MASSACHUSETTS DEPARTMENT OF TRANSPORTATION HIGHWAY DIVISION

SPRINGFIELD MCKNIGHT COMMUNITY TRAIL			
STATE	FED. AID PROJ. NO.	SHEET NO.	TOTAL SHEETS
MA	-	1	66
PROJECT FILE NO.		608157

PLAN AND PROFILE OF MCKNIGHT COMMUNITY TRAIL

25% SUBMITTAL

TRAFFIC SIGNAL PLAN

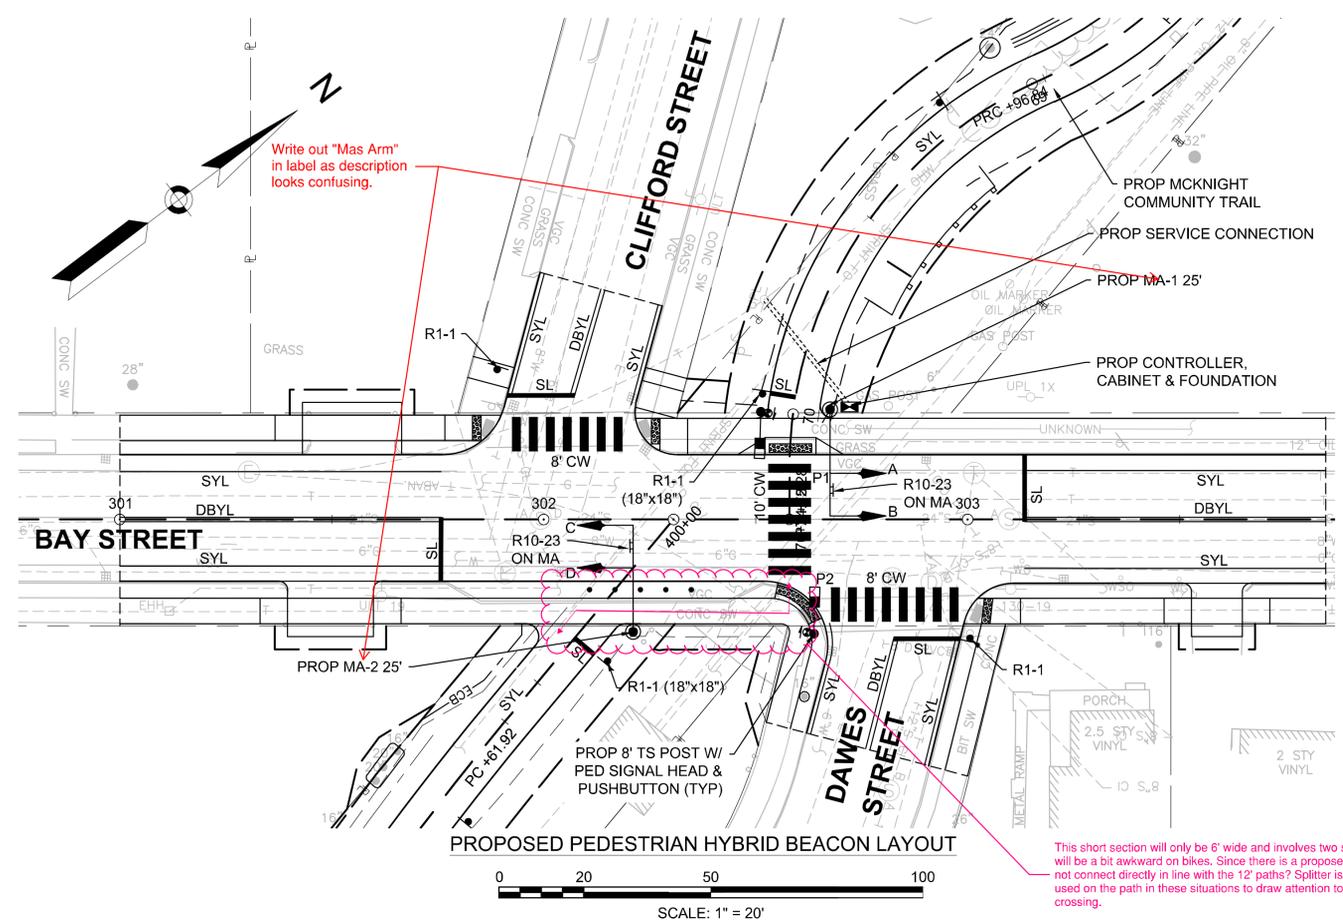
Write out "Mas Arm" in label as description looks confusing.

??? Revise

Include item for conduit in plus ALL MISCELLANEOUS EQUIPMENT AND MATERIAL NECESSARY major items list. Be sure to provide a complete operating traffic control signal. show the location of conduit on plans.
